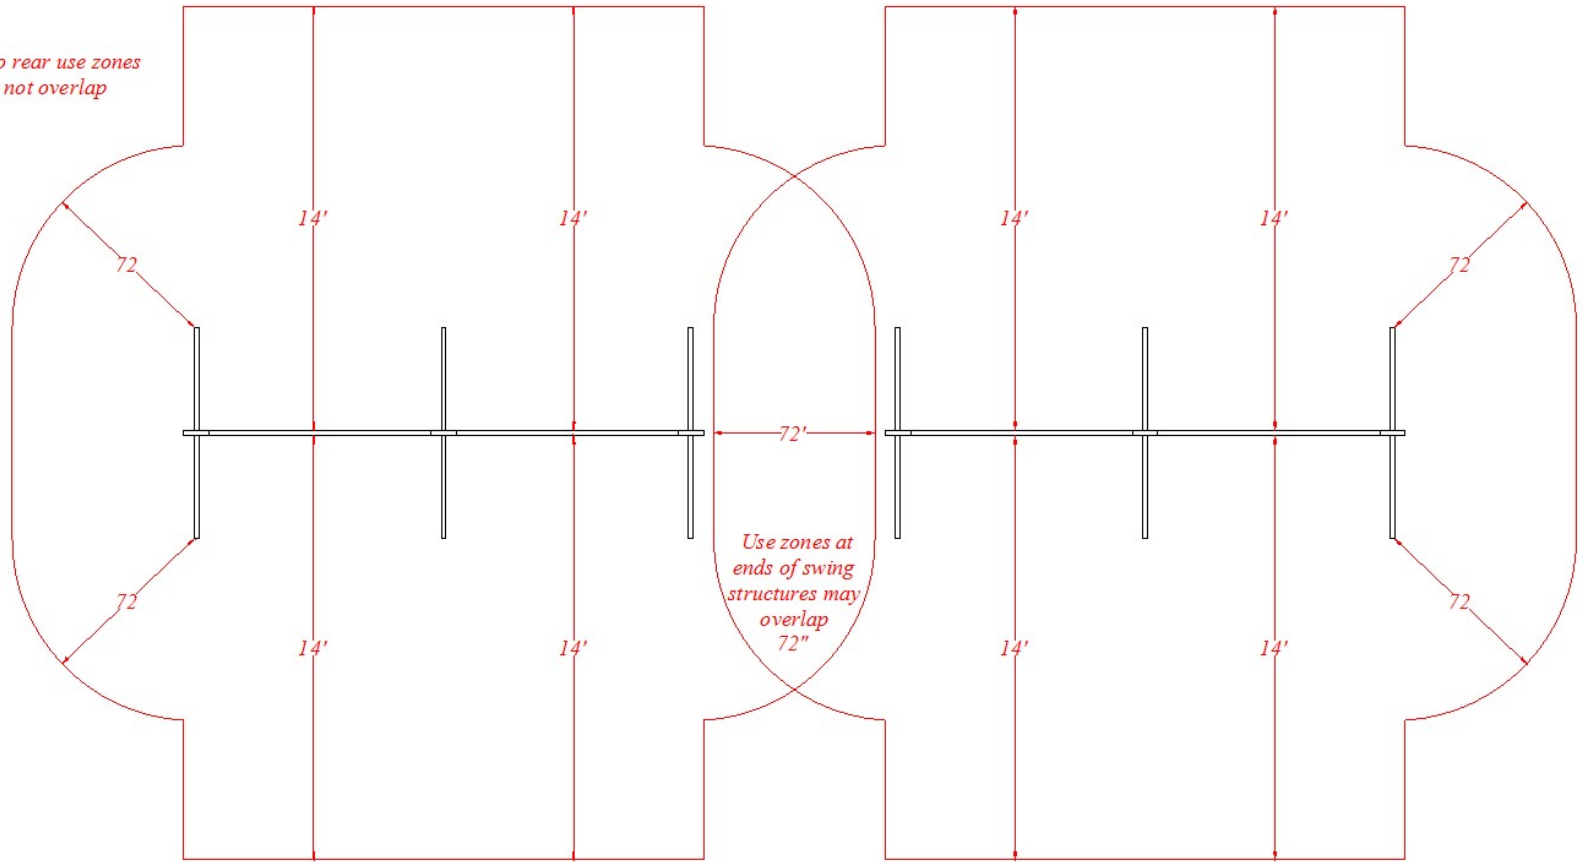
*Front to rear use zones  
can not overlap*

*Use Zone for To-Fro Swings Follow ASTM 9.4.1.2, 9.4.1.3, 9.4.1.4, 9.4.1.5 and 9.4.1.5 (1)*
